# Capitol Expressway Light Rail

### **Final Supplemental Environmental Impact Report** Volume I Draft Supplemental Environmental Impact Report and Response to Comments State Clearinghouse #2001092014

### **Capitol Expressway Light Rail Project**

# Final Supplemental Environmental Impact Report

# Figure 3-2 Project Changes at Story Road

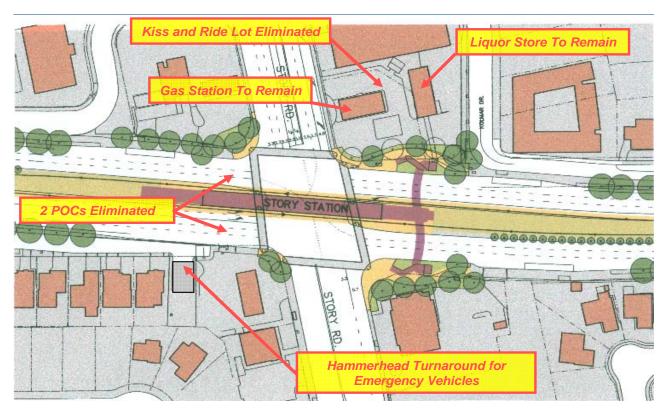
- 3. Page 3-3 Figure 3-2(Proposed Changes to Project) is not acceptable. The elimination of the two Pedestrian Over crossings impacts the intersection because people accessing LRT must use existing signalized crossing.
